Intersection ID: 10031994	Main Street: MONROE_RD	Cross Street: N/A	Location:	NE
ADA ID: 6B52D85F3DF3	Ramp Type: ParaDiag	Initial Pass/Fail: Fail	Overall Compliance: No	Severity Score: 13.75

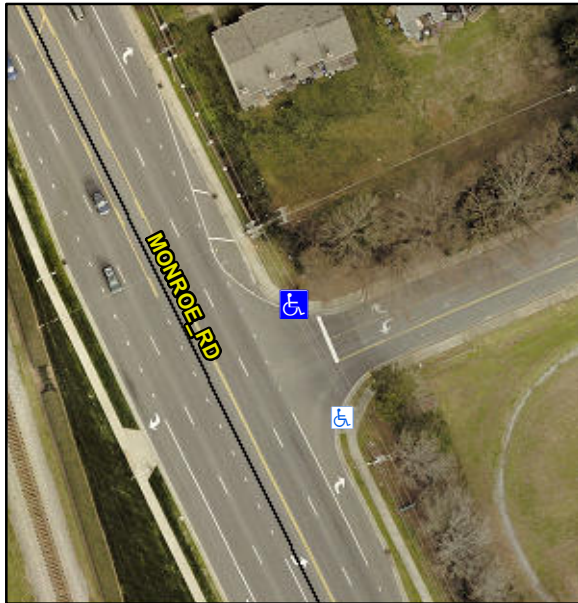
**RT RP < 5%**

**R304.3.2, R304.5.3**

Compliance	Description	Data	Compliance	Description	Data
N/A	Ramp Length LT (in)	59.0	N/A	Ramp Length RT (in)	69.0
Yes	Ramp Width LT (in)	59.0	Yes	Ramp Width RT (in)	59.0
No	Ramp Slope LT (%)	9.7	Yes	Ramp Slope RT (%)	4.7
No	Ramp XSlope LT (%)	4.4	No	Ramp XSlope RT (%)	2.8
N/A	Landing Length (in)	N/A	N/A	DWS Provided?	N/A
N/A	Landing Width (in)	N/A	N/A	DWS Contrast?	N/A
N/A	Landing Slope (%)	N/A	N/A	DWS Length (in)	N/A
N/A	Landing X Slope (%)	N/A	N/A	DWS Full Width?	N/A
N/A	Landing Curb? (Y/N)	N/A	N/A	DWS Offset (in)	N/A
N/A	Shared Landing?	N/A			
N/A	Gutter Ponding?	N/A	N/A	Gutter Slope (%)	N/A
N/A	Gutter Lip Ht (in)	N/A	N/A	Gutter X Slope (%)	N/A
N/A	Painted X Walk1?	No	N/A	Painted X Walk2?	No
	X Walk 1 Direction	To W		X Walk 2 Direction	To S
N/A	X Walk 1 Width (in)	N/A	N/A	X Walk 2 Width (in)	N/A
	X Walk 1 Slope (%)	2.3		X Walk 2 Slope (%)	1.3
	X Walk 1 X Slope (%)	0.7		X Walk 2 X Slope (%)	1.4
N/A	Ramp inside XWalk1?	N/A	N/A	Ramp inside XWalk2?	N/A

**Remove & Replace Curb Ramp With Two New Directional Ramps or Equivalent.**
